Comment Letter - AB 2121 Policy And Request for Extension of Time

Subject: Preliminary Analysis of AB2121 Policy

Figure 1

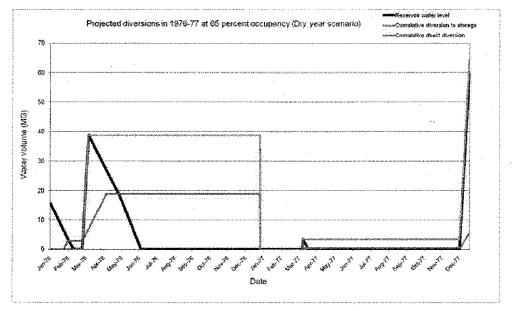
Figures 1 and 2 below summarize Brown and Caldwell's findings for two dry year periods (1976 to 1977 and 1989 to 1991), respectively. Figure 3 below summarizes our findings for an average year (2004 to 2005). All graphs are based on 65 percent year-round occupancy level. Reservoir volume at the start of the year was assumed to be 15.6 million gallons (MG) (48 acre feet [AF]) - about 16 percent of total reservoir capacity of 97.8 MG (300 AF).

As shown in Figures 1 through 3, all three scenarios failed to meet Sea Ranch's water demand at the 65 percent year-round occupancy level, a reasonable estimate of build out occupancy. The following key points are noted with respect to the resulting impact on Sea Ranch operations:

- Using 1976 to 1977 dry year scenario, less than 15 percent year-round occupancy level could be served with water without letting the reservoir run dry. When 1989 to 1991 dry year scenario was used, about 25 percent year-round occupancy level could be served without letting the reservoir run empty.
- Assuming the current year-round occupancy level (about 43 percent), the reservoir would be empty about 96 percent of the time (approximately 351 days) using a 1976 to 1977 dry year scenario and about 22 percent of the time(approximately 160 days) using a 1989 to 1991 dry year scenario. During periods when the modeling predicts that the reservoir would be dry, the policy also would not allow diversions by TSR. Hence, no water would available

Figure 3

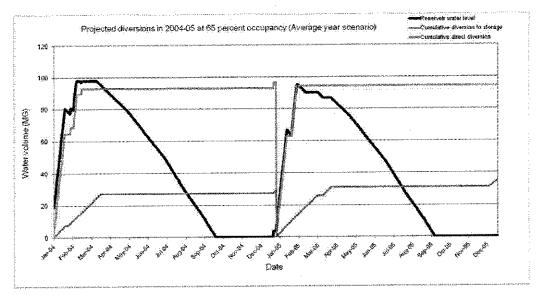
- * Using 2004 to 2005 average year scenario, 35 percent year-round occupancy level could be served with water without letting the reservoir run empty.
- With current year-round occupancy level (about 43 percent), the reservoir would be empty about 7 percent of the time(approximately 26 days) using 2004 to 2005 average year scenario. During periods when the modeling predicts that the reservoir would be dry, the policy also would not allow diversions by TSR. Hence, no water would available.
